CHEROKEE COMMENTS
7-7-2021 JKM

MEADOWBROOK PARK
EL PASO COUNTY, COLORADO
UTILITY AND WATER SERVICE PLANS
GENERAL NOTES

PROJECT NO.
096956009

TYPICAL UTILITY SERVICE CONNECTIONS DETAIL

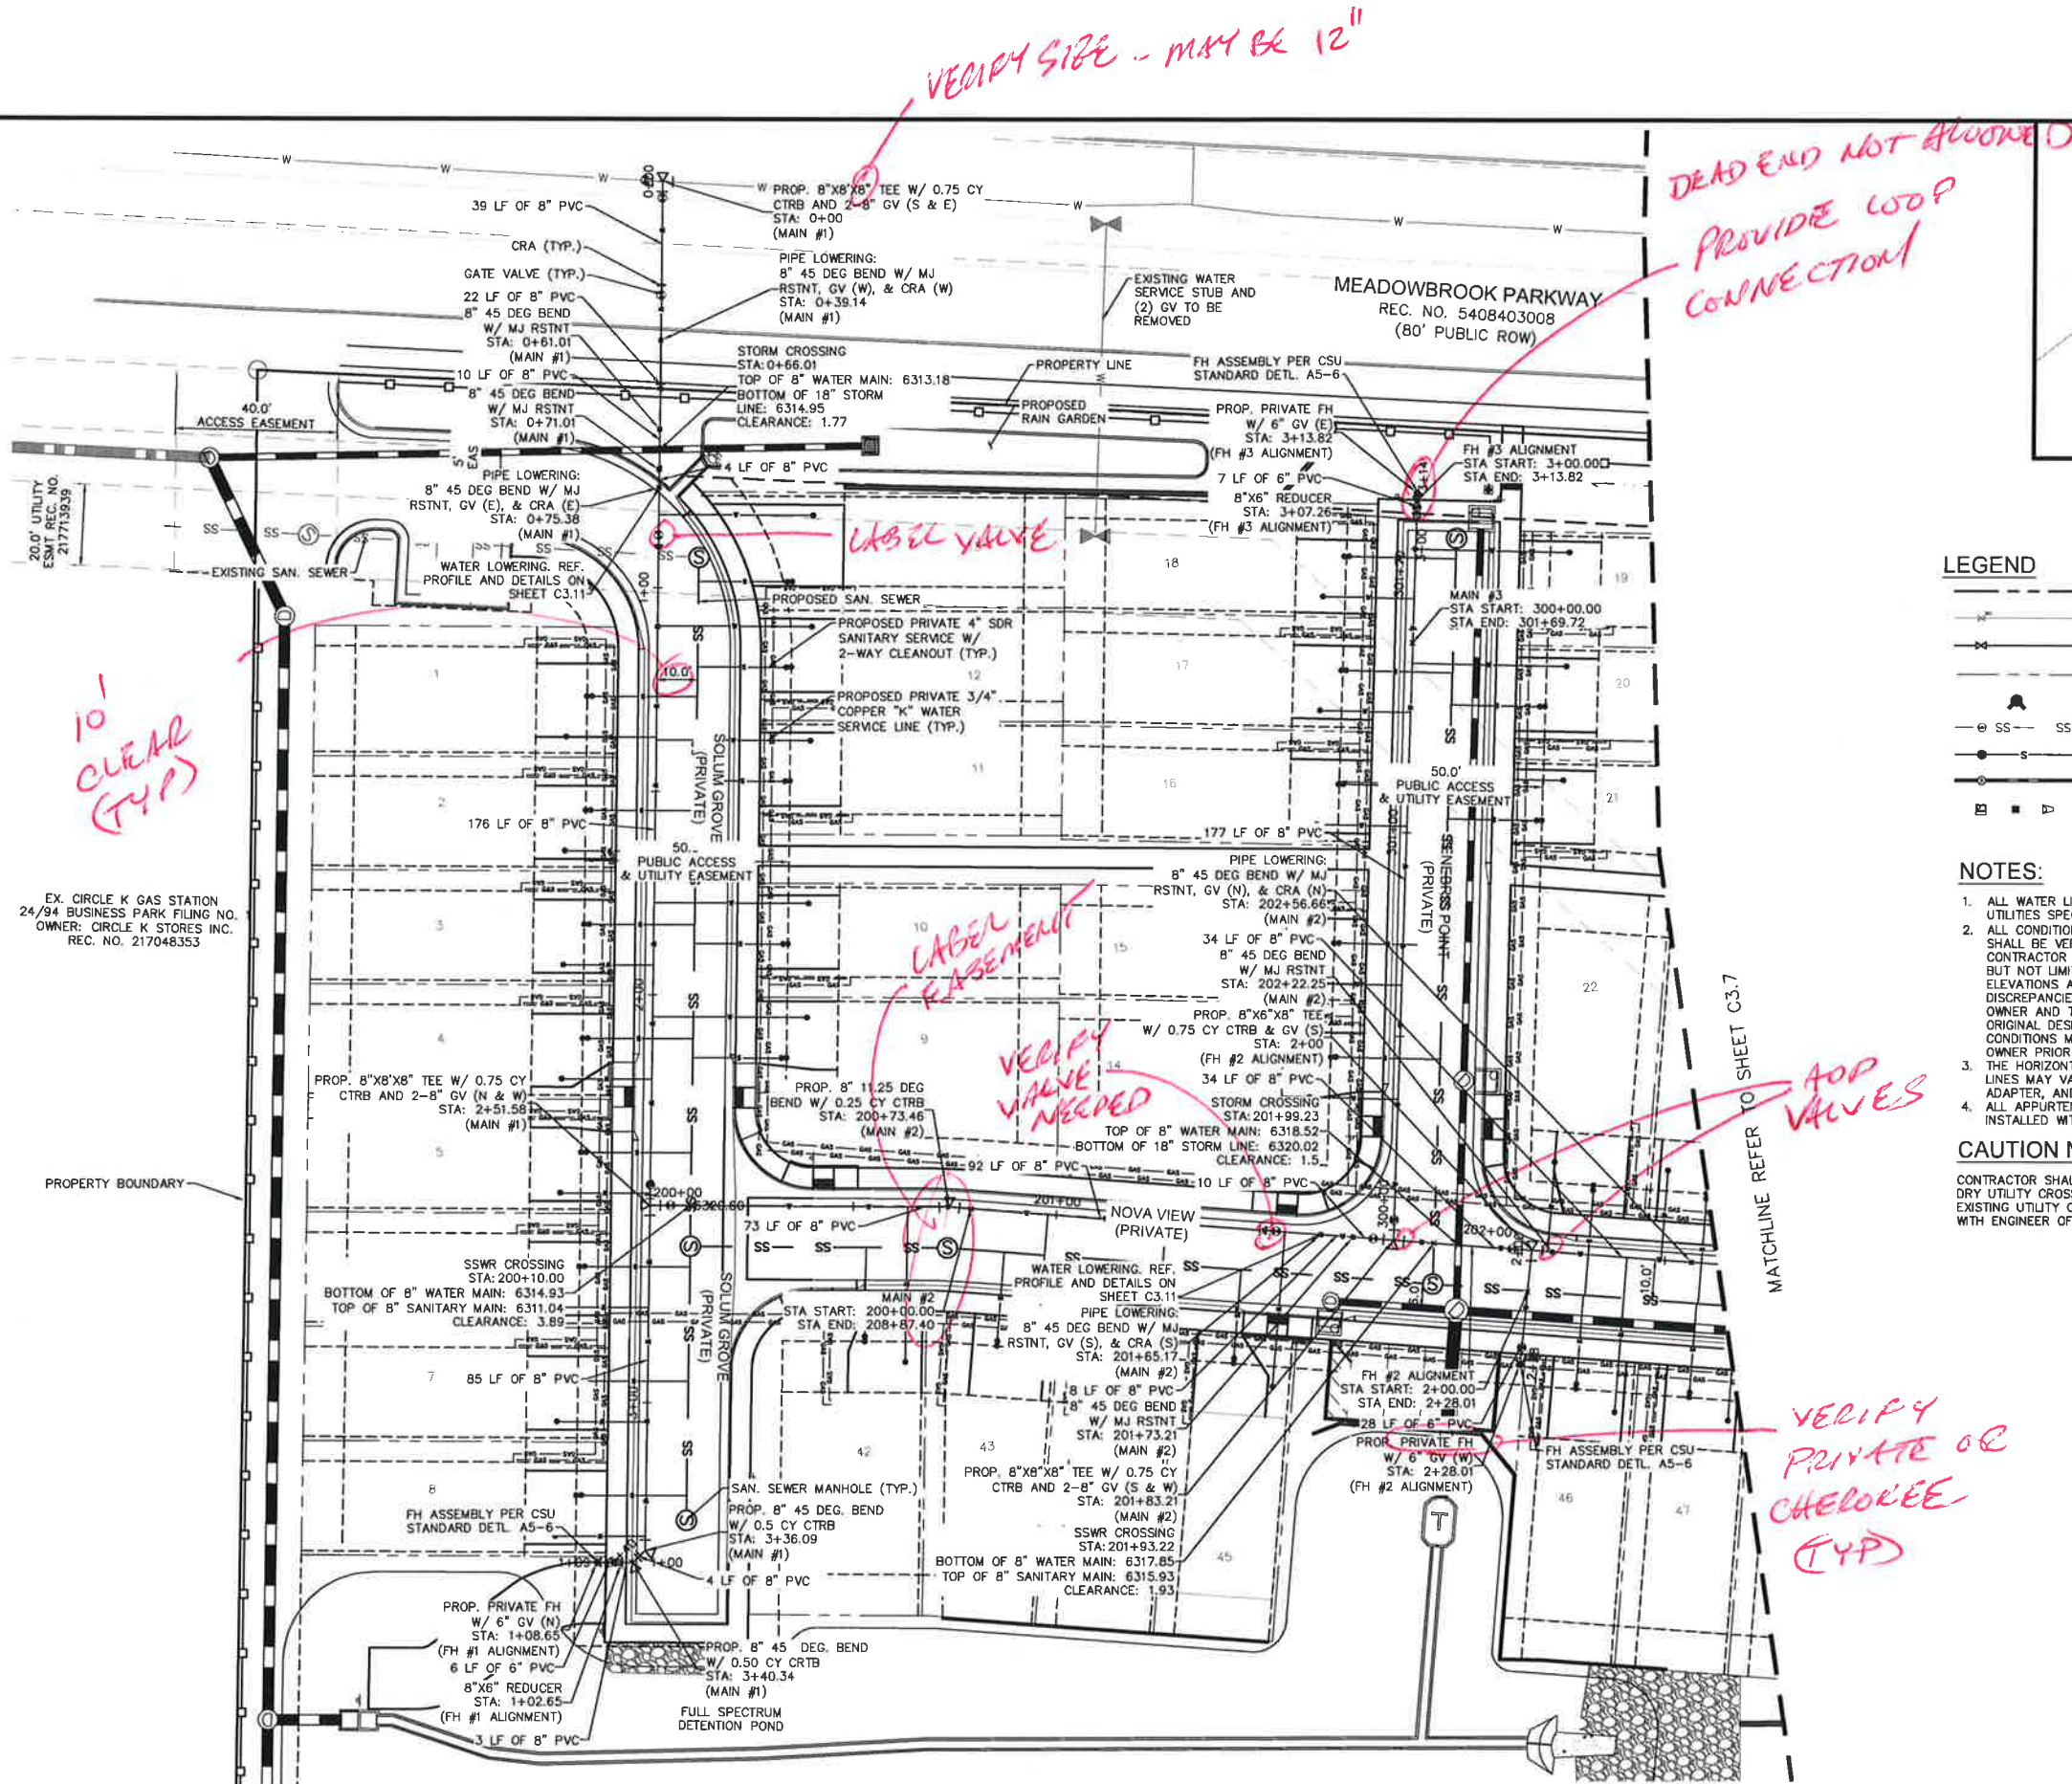
NO DEAD END ALLOWED
PROVIDE
LOOP CONNECTION

INSTALL JOINTS
FOR 4'x4'
LOCATION OF
CONCRETE SLAB
FOR REPAIR.
REPAIR OF DRIVEWAY
HOA RESPONSIBILITY
CHECKER RESPONSIBILITY
ENDS AT MAIN TAP
FOR WATER & SEWER

C3.8

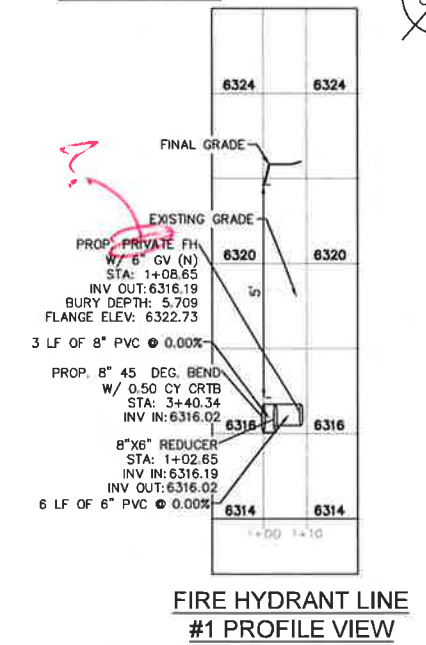
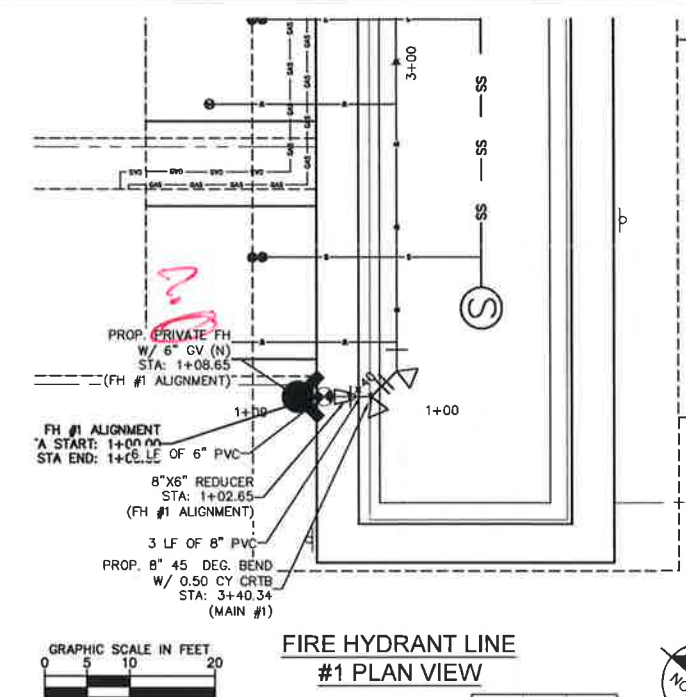
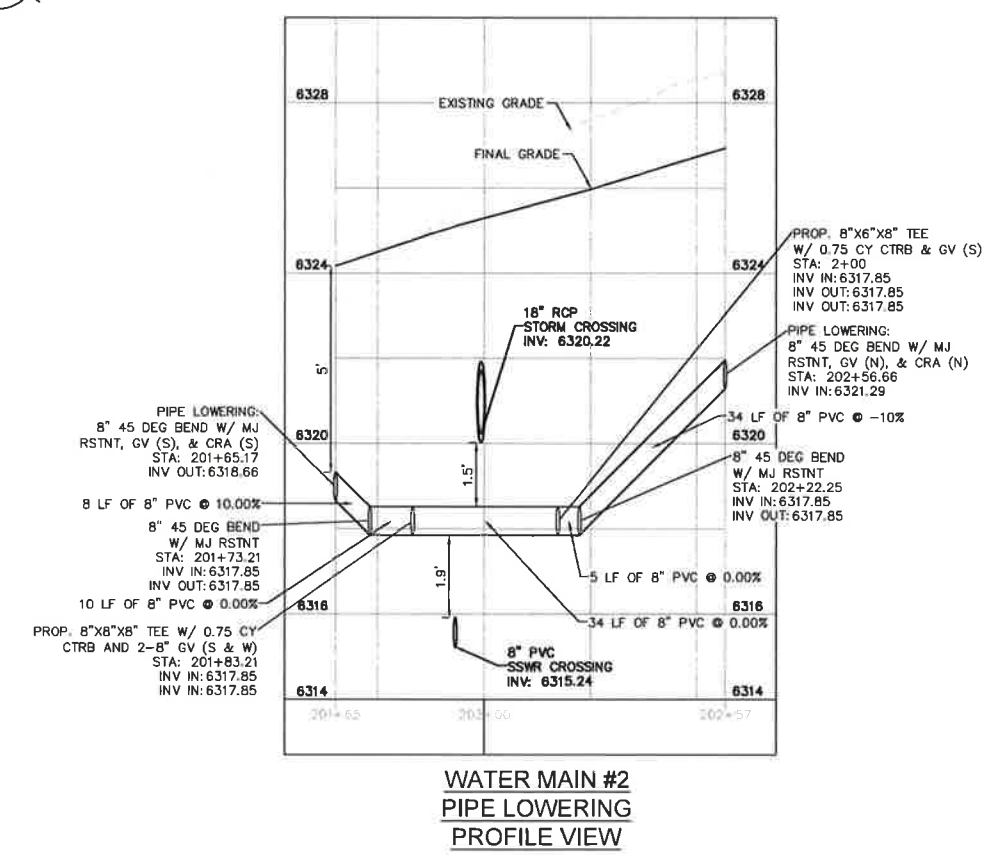
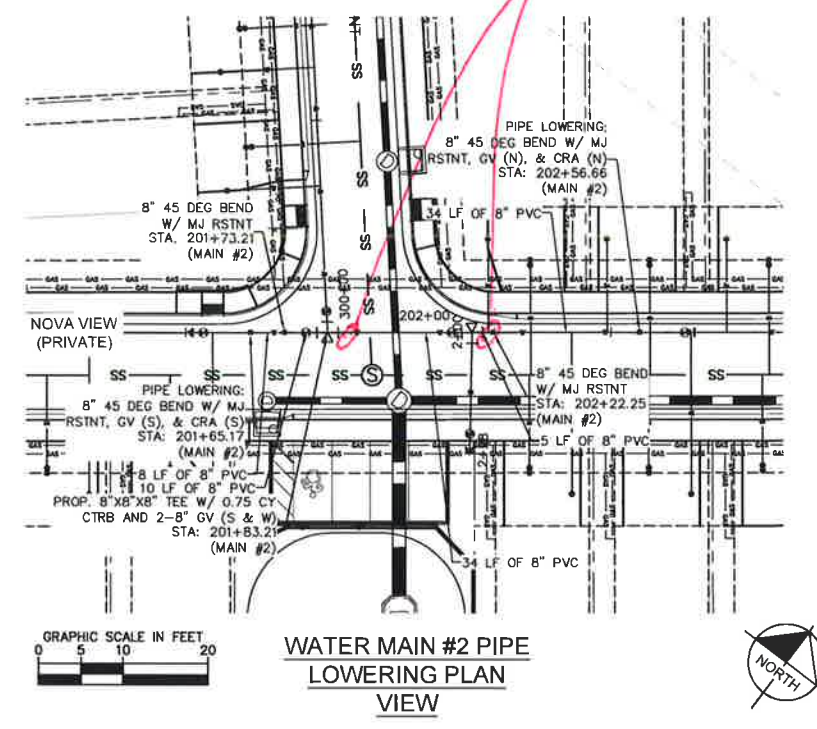
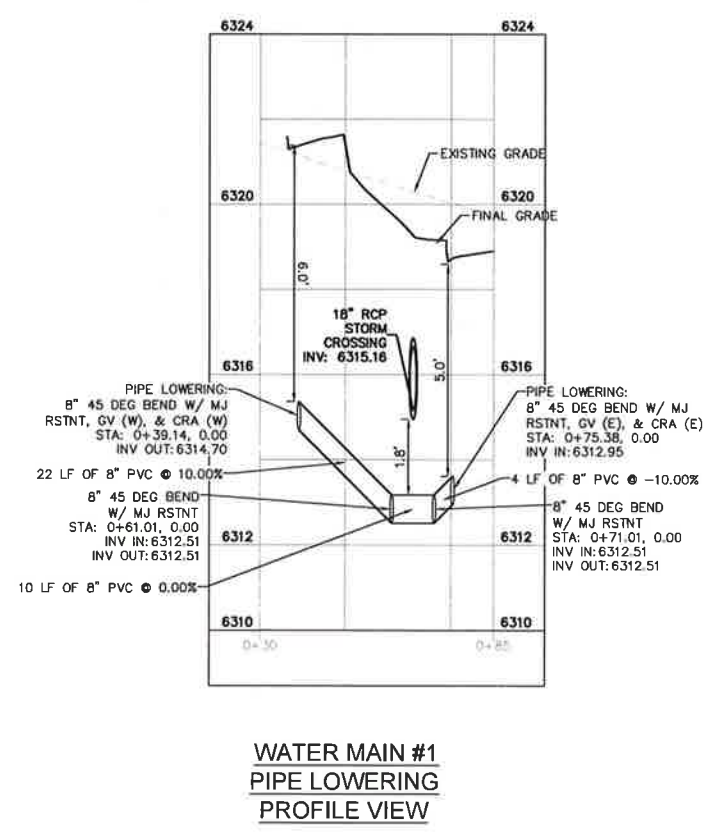
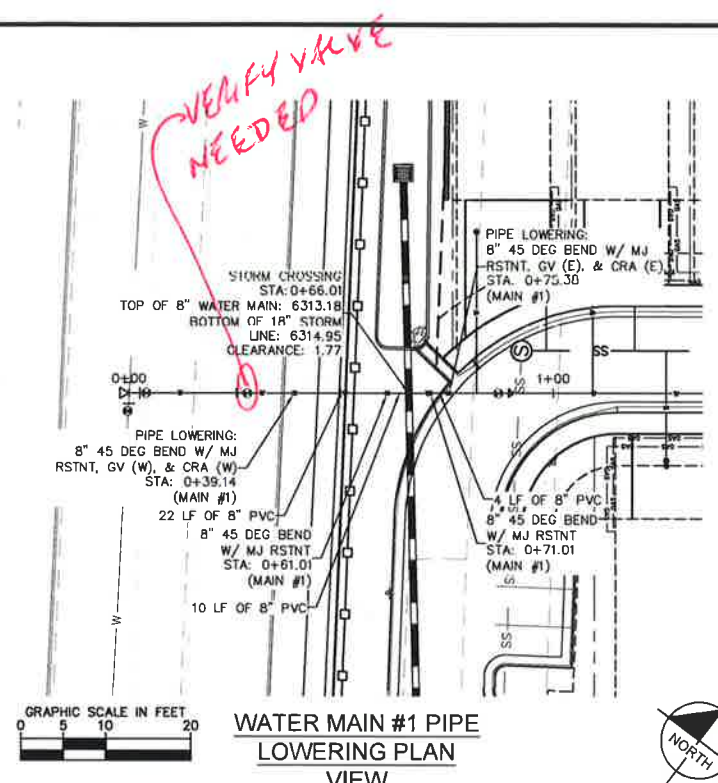
DUPLICATE
NUMBER

FIRE HYDRANT LINE
#2 PLAN VIEW

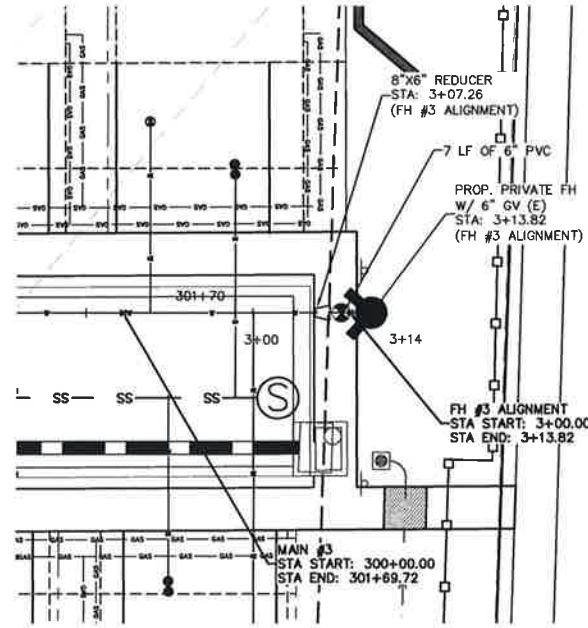
ADD
VALVE
